County of Loudoun

MEMORANDUM

SUBJECT: **April 21, 2010 Planning Commission Work Session**
Kincora Village Center, ZMAP 2008-0021

ZONING MAP AMENDMENT
(APPLICATION # ZMAP 2008-0021)
KINCORA VILLAGE CENTER
BROAD RUN ELECTION DISTRICT
LOUDOUN COUNTY, VIRGINIA

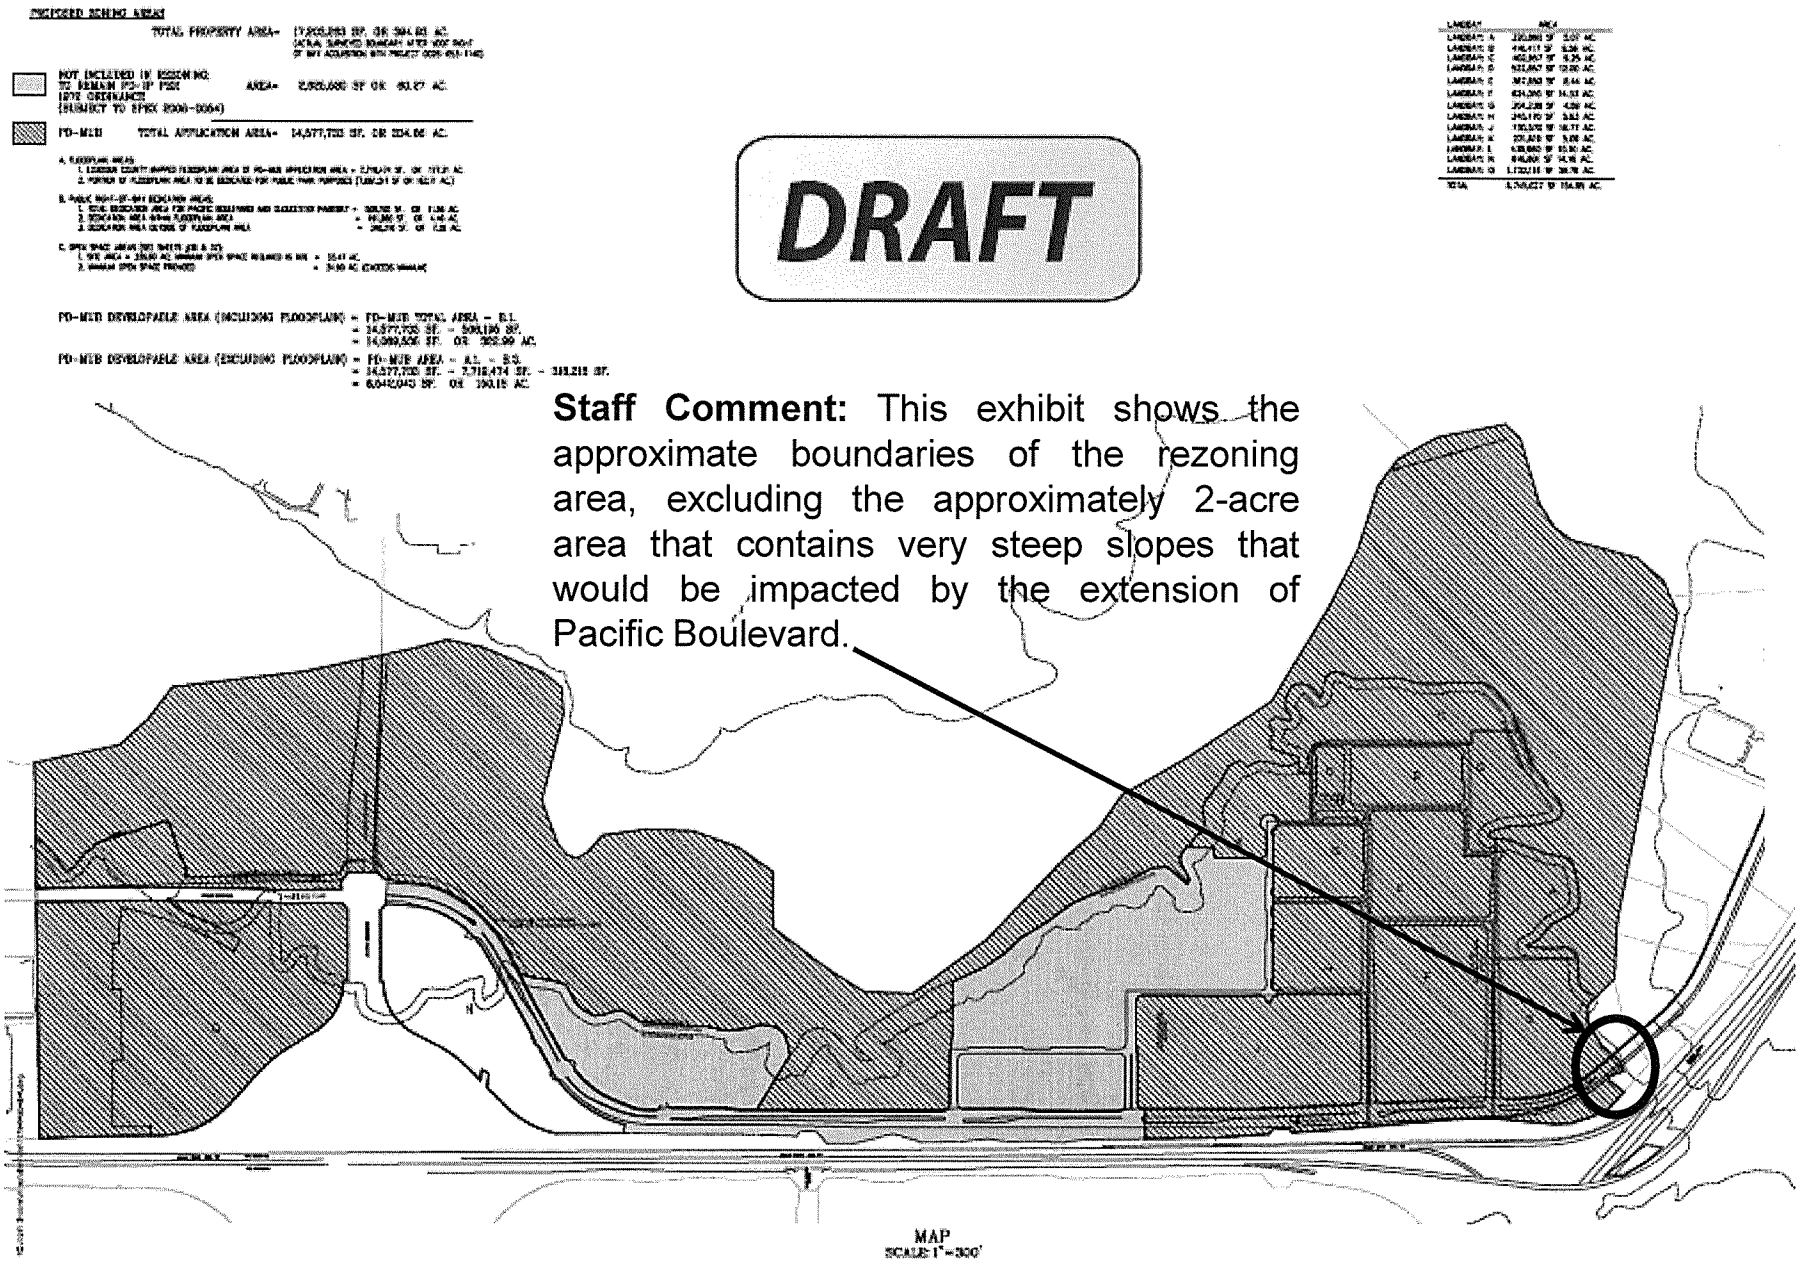
Very Steep Slopes
Any alignment of Pacific Boulevard extended to Russell Branch Parkway would impact very steep slopes, which is prohibited by Section 5-1508 of the Revised 1993 Zoning Ordinance (ZO). As a solution, considering that the existing zoning under the 1972 Zoning Ordinance does not prohibit road construction within very steep slopes, Staff has included in the draft motions a recommendation to exclude the approximately 2-acre portion of the subject property that contains very steep slopes from the rezoning application (see page A-81). Staff acknowledges that impacts to the very steep slopes would be an environmental loss; however, in this case, given the poor level of service in this area, Staff finds that providing the regional roadway connection takes priority. Staff notes that Section 6-1211(B) of the ZO allows the PC to recommend that a smaller land area be rezoned, without requiring re-advertising and re-hearing. The applicant would need to revise the Concept Plan accordingly prior to Board action to accommodate this potential revision.

DRAFT
Staff Comment: This exhibit shows the approximate boundaries of the rezoning area, excluding the approximately 2-acre area that contains very steep slopes that would be impacted by the extension of Pacific Boulevard.
MAP
SCALE: 1"=300'

a. The land area subject to the rezoning is reduced by approximately two acres, as depicted on Attachment 4, to exclude areas of very steep slopes that would be impacted by the construction of Pacific Boulevard, and
   b. The requested modifications of the Land Subdivision Development Ordinance (LSDO) and the Facilities Standards Manual (FSM), identified on pages 4, 5, and 6 of Exhibit B to the Proffer Statement dated April 12, 2010, are excluded from the recommendation of approval.
